**Validation report form for post-registration changes for
CDM project activities
(Version 02.0)**

Title and UNFCCC reference number of the project activity	Hebei Shangyi CGN Dongshan Wind Power Project
Process track	<input type="checkbox"/> Prior approval <input checked="" type="checkbox"/> Issuance <input type="checkbox"/> Renewal of crediting period
Version number of the validation report on PRCs	01
Completion date of the validation report on PRCs	30/09/2018
Type(s) of PRCs	<input type="checkbox"/> Temporary deviations from the registered monitoring plan, monitoring methodology or standardized baseline <input type="checkbox"/> Corrections <input type="checkbox"/> Changes to the start date of the crediting period <input type="checkbox"/> Inclusion of a monitoring plan to a registered project activity <input checked="" type="checkbox"/> Permanent changes from registered monitoring plan, monitoring methodology or standardized baseline <input type="checkbox"/> Changes to the project design of a registered project activity <input type="checkbox"/> Types of changes specific to afforestation and reforestation project activities

Name and UNFCCC reference number of DOE	Shenzhen CTI Int

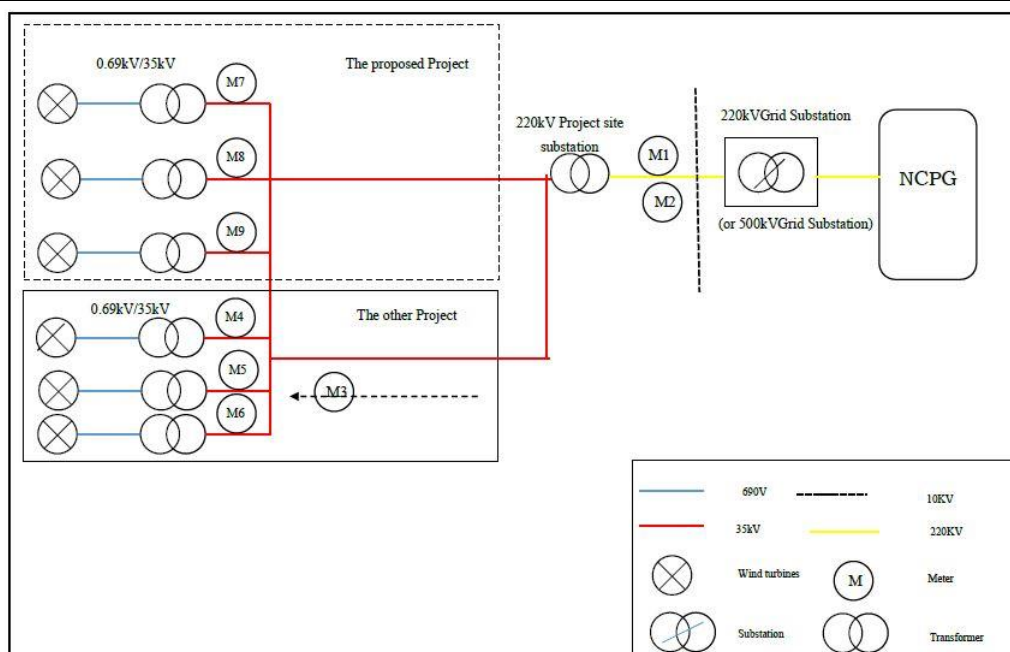
Means of validation	<p>The post-registration changes to the registered monitoring plan is identified during the process performing the 1st verification of Hebei Shangyi CGN Dongshan Wind Power Project. The changes are assessed in accordance with applicable validation requirements related to the permanent changes from the registered monitoring plan in the CDM validation and verification standard for project activities as below:</p> <p>As per the monitoring plan of the registered PDD, the electricity would be monitored by the main meter and the backup meter installed at the project site.</p> <p>As per the requirement of the Grid Company /5/, the proposed project shares the gate meter M1 and the backup meter M2 with the Hebei Shangyi Dongshan Wind Power Project to monitor the electricity supplied to the grid and the electricity consumed by these two projects. For the purpose of invoicing, another six meters (M4, M5, M6 and M7, M8, M9) are installed at the 35kV transmission lines of the Hebei Shangyi Dongshan Wind Power Project and the project respectively. (as shown below).</p>

Note: The meter M3 and the spare 10kV agriculture line used for the Hebei Shangyi Dongshan Wind Farm project only.

Findings	CAR-01: In the registered PDD, it stated that "The meter(s) will be installed at the onsite substation in accordance with industry standards". However, by on-site visit, CTI found that the project shared the gatometer and backup meter which was installed at the high volt side of 220kV Substation with the other project (Hebei Shangyi Dongshan Wind Power Project). (Refer to Appendix 4)
Conclusion	CTI confirms that the post-registration changes comply with the relevant requirements related to the permanent changes from the registered monitoring plan in the CDM project standard for project activities (Ver. 1.0) and do not require the prior approval by the EB.

CAR ID	01	Section no.	D.6	Date: 21/09/2018
Description of CAR				
In the registered PDD, it stated that "The meter(s) will be installed at the onsite substation in accordance with industry standards". However, by on-site visit, CTI found that the project shared the gate meter and backup meter which was installed at the high volt side of 220kV Substation with the other project (Hebei Shangyi Dongshan Wind Power Project).				
Project participant response				Date: 28/09/2018
There are permanent changes to the registered monitoring plan, Changes that are being submitted with this monitoring report as part of the request for issuance (post-registration change - issuance track) as applicable from this monitoring period.				
Documentation provided by project participant				
Diagram of power connection system				
DOE assessment				Date: 30/09/2018
The Revised PDD has been provided by PP to indicate the permanent changes in the monitoring system. The Verification Team confirms the updated monitoring system is consistent with the actual condition and according to the requirement of the Grid Company. As per the Ver.1.0 of CDM project standard for project activities, these changes do not need to get the prior approval from EB. Therefore, the Revised PDD will be submitted following the verification documents. CAR 1 is closed.
